Change 1 from NIC's new file 20220301:  
The position for SD is longer  
----- OK ,no problem from Hasion 3.1

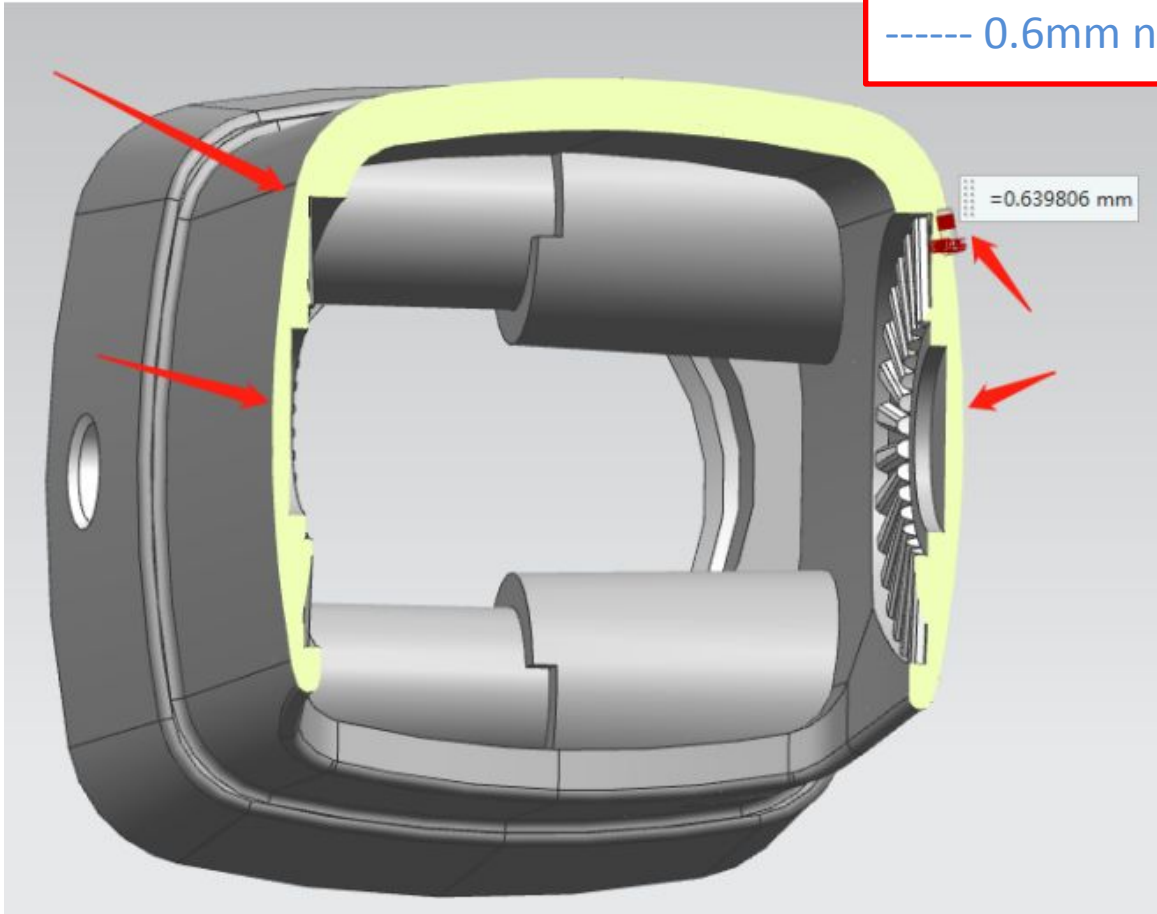
Change 2 from NIC's new file 20220301:  
The position for gear  
----- OK ,no problem from Hasion 3.1

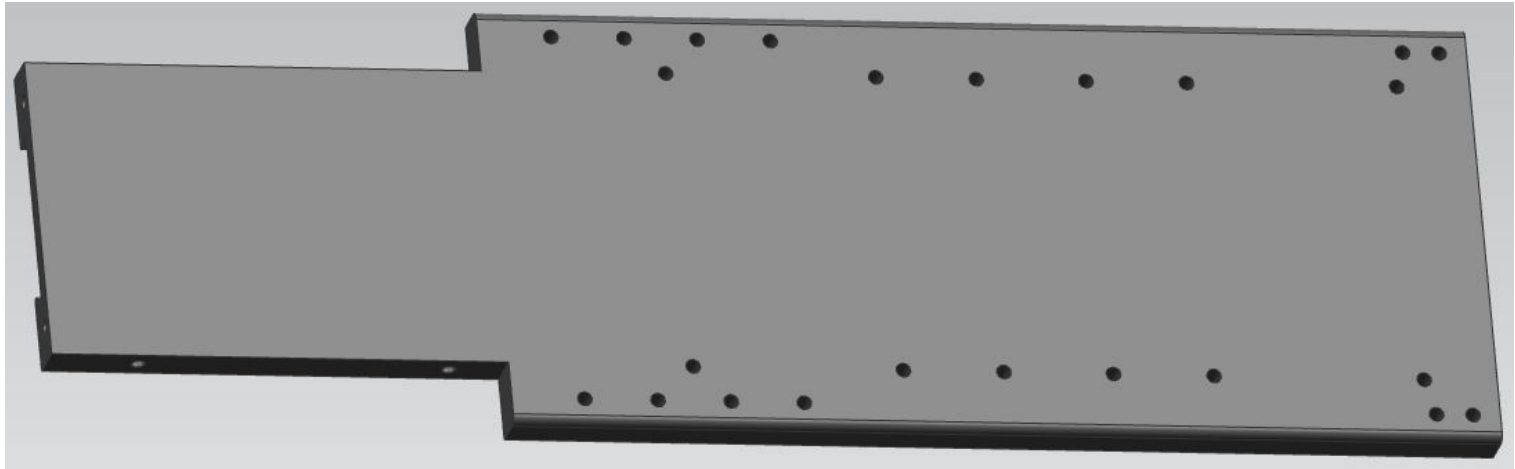
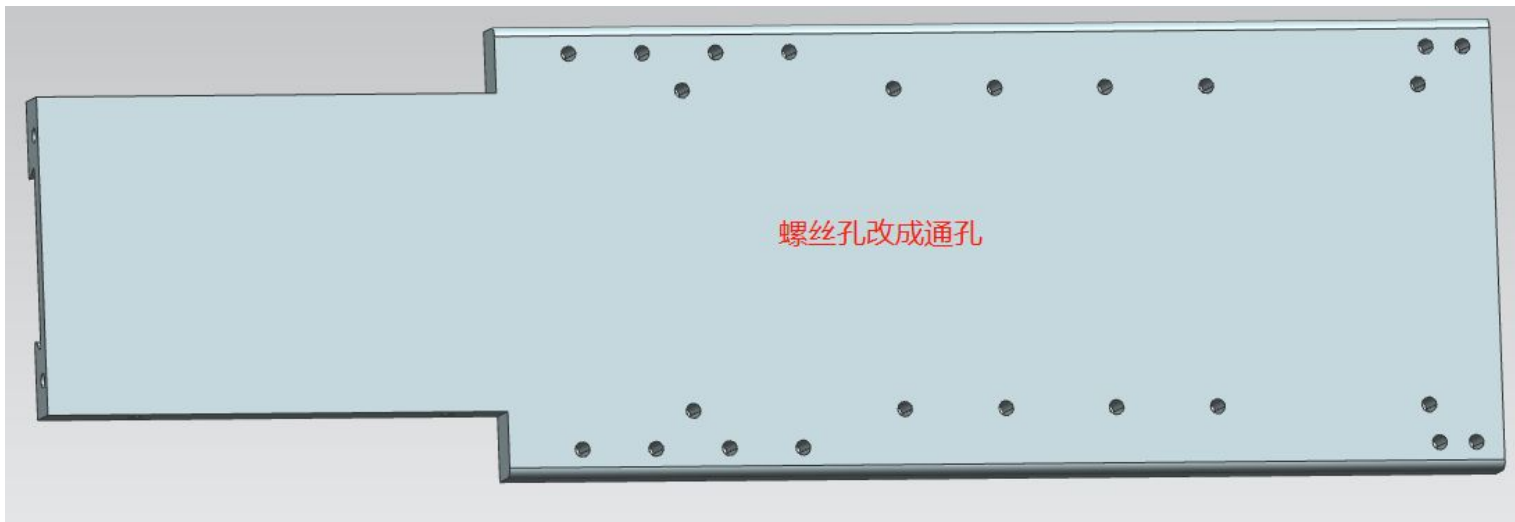
Change 3 from NIC's new file 20220301:

The thickness for here position

----- 0.6mm not OK , It at least 1.2mm--Hasion.3.1

because only 0.6mm thickness ,  
too thin , easy to be broken

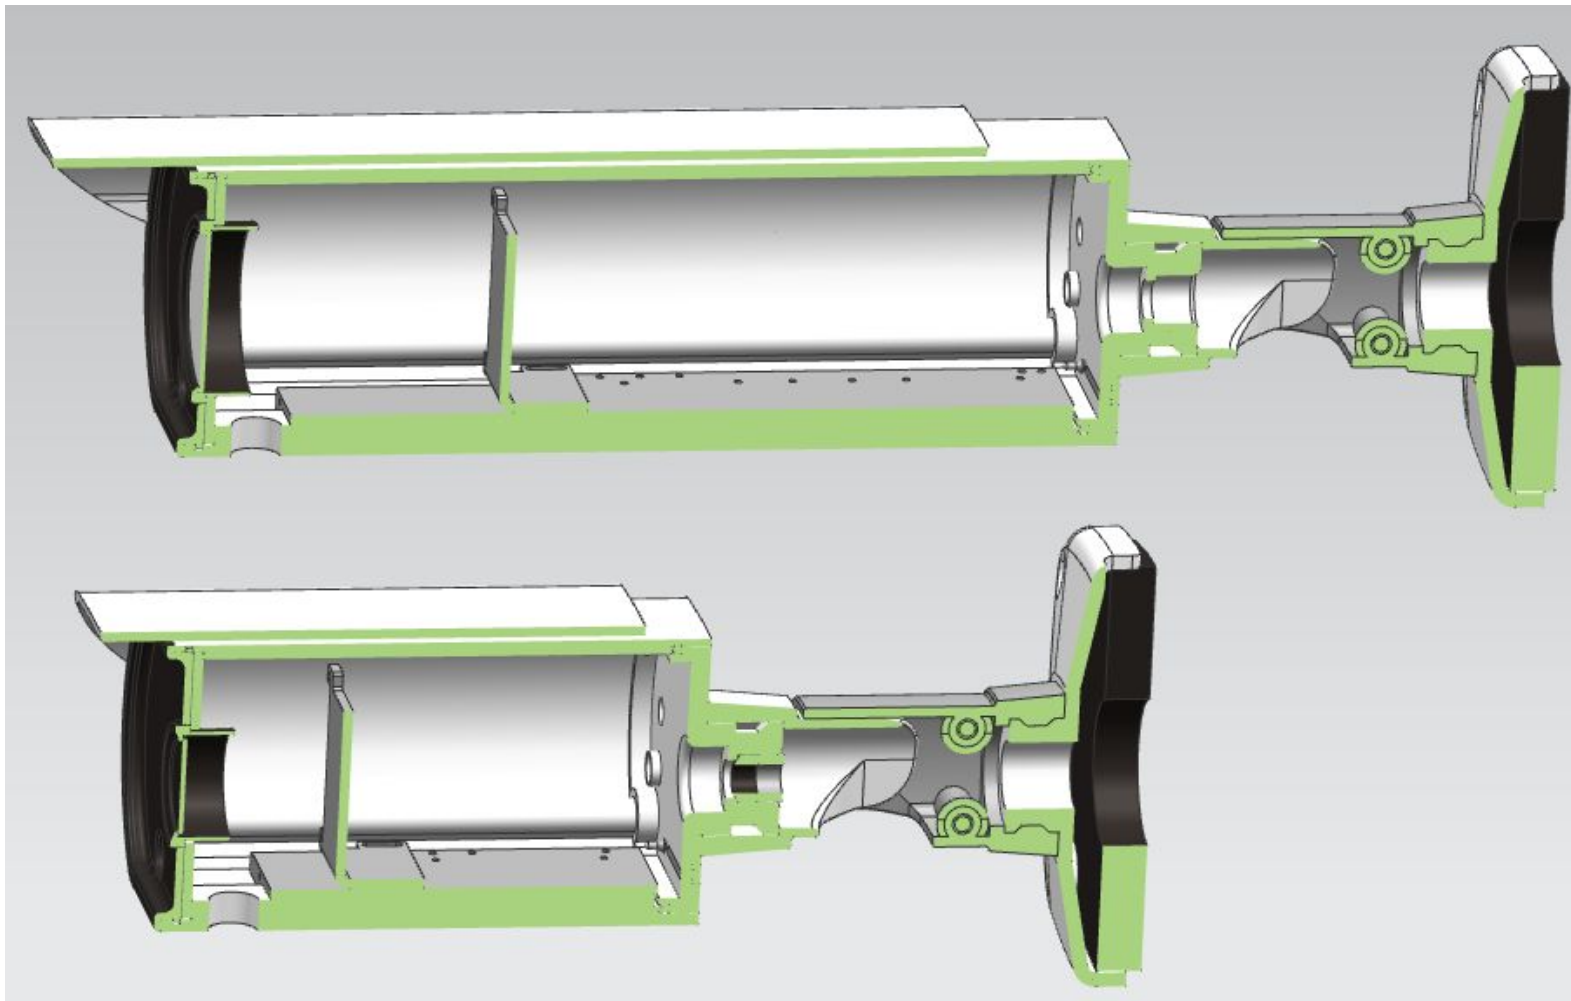
Change 4 from NIC's new file 20220301:  
the hole is through hole type

Problem 5 from NIC's new file 20220301:  
fixing way of the bracket board

-----the fixing way is not unreasonable, it doesn't improve the fixing --  
Hasion 3.1
